From: Dan Chipman [dchipman@wright-ryan.com]
Sent: Tuesday, December 12, 2006 9:43 AM
To: 'Matt Wirth'
Cc: 'Tim Levine'; 'Randy Allred'; 'Craig Hill'; tnaason@esboulos.com; acsinc@maine.rr.com
Subject: Electrical Room
Follow Up Flag: Follow up
Flag Status: Red

CUSTOM HOUSE SQUARE
PORTLAND, MAINE
PARTIAL FLOOR PLAN LOWER LEVEL

PROJECT # 300506
REF SHEET A2.3
SKETCH
SKA-08
02/02/07

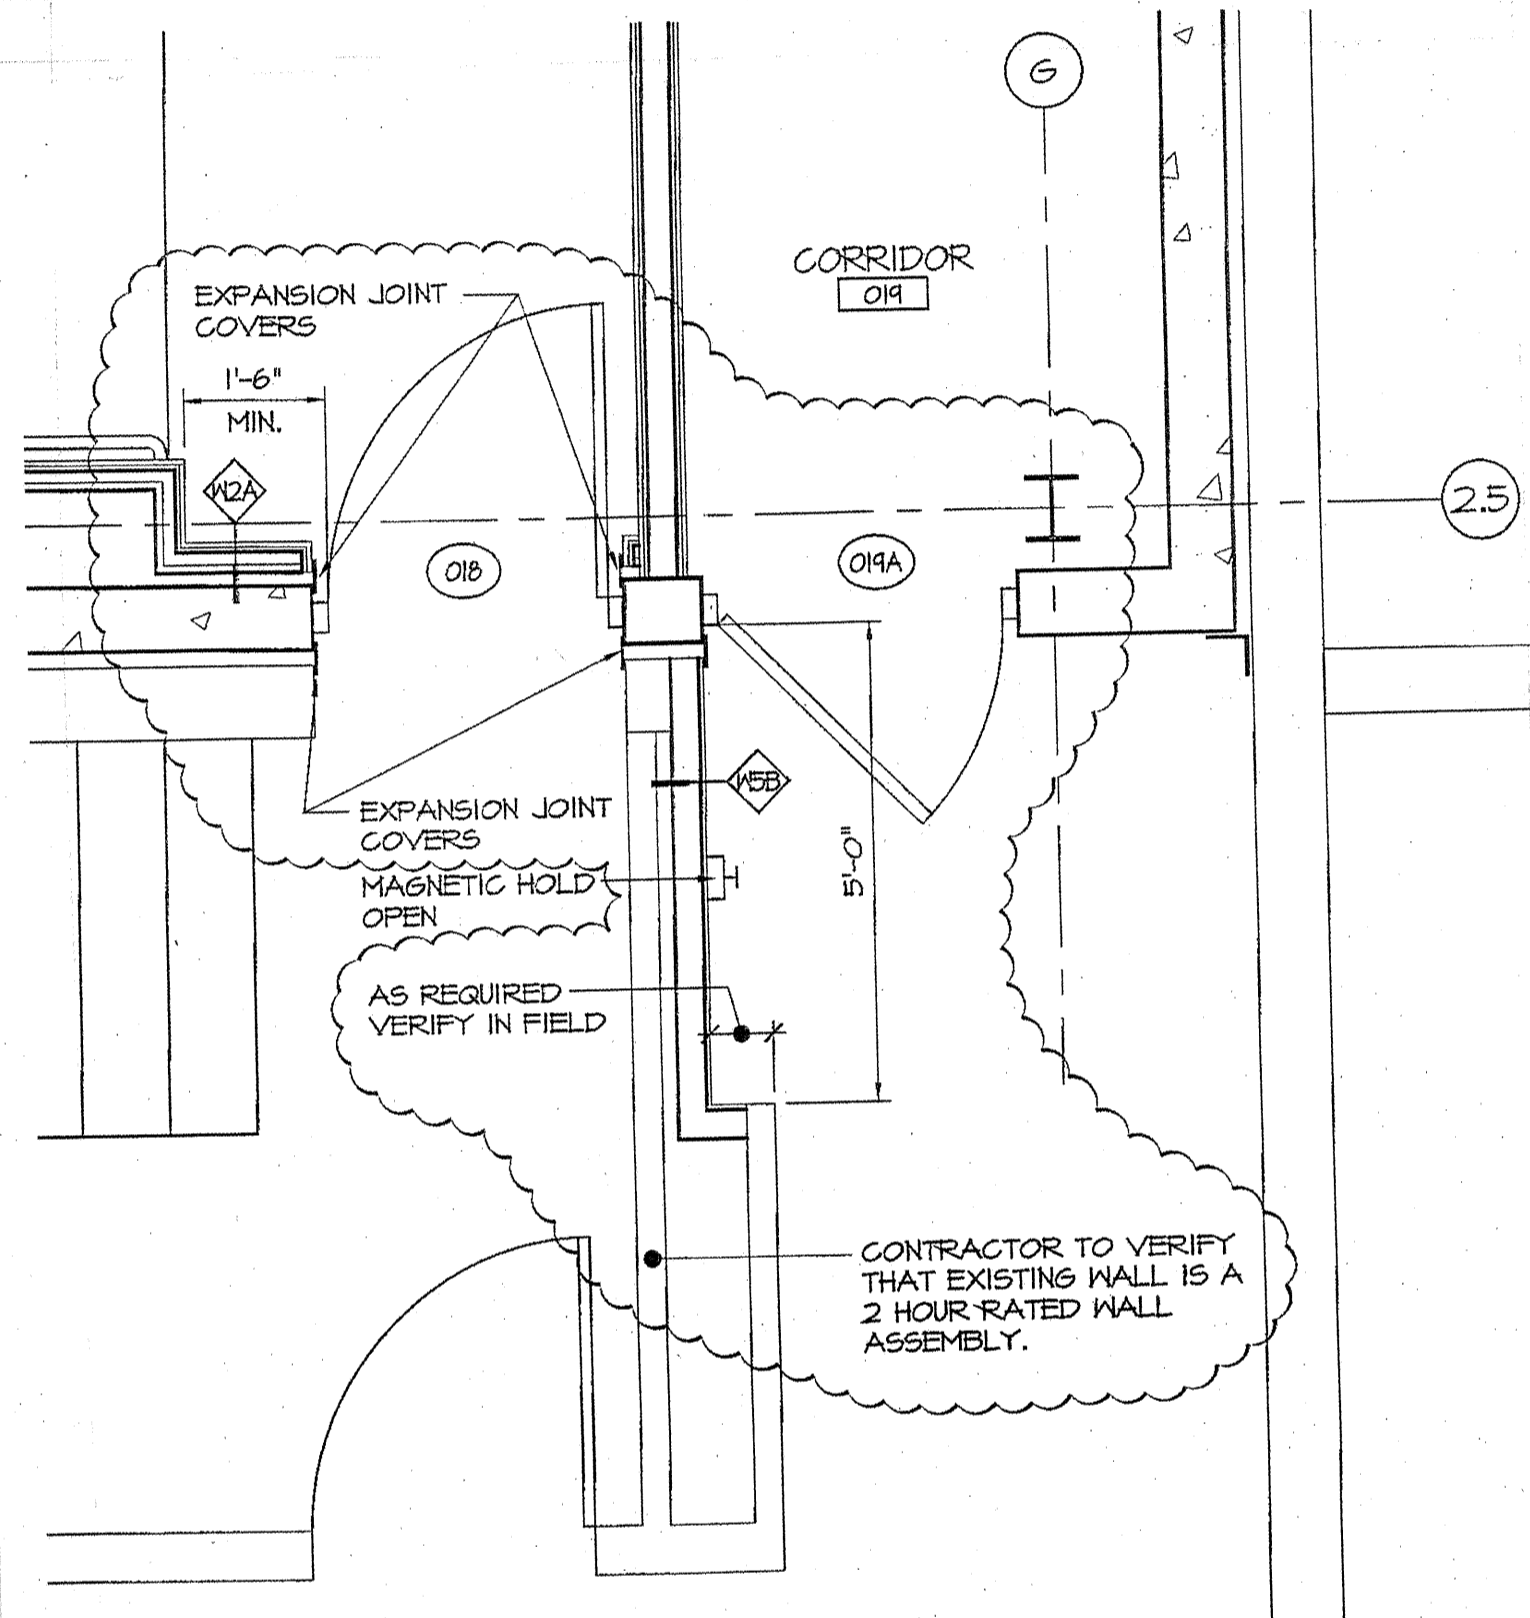
1. The Water Room (008) will now be the Electrical Room. This provides wall space enough for the Switch Gear.
2. The Mechanical Room (007) will be a combination Water and Mechanical Room. This allows room for the Sewer Ejector, Water Heater, Water Meter. Sprinkler can be in the proposed unused space or new water room.
3. The Room that was to be the Electrical (009) can now be storage.
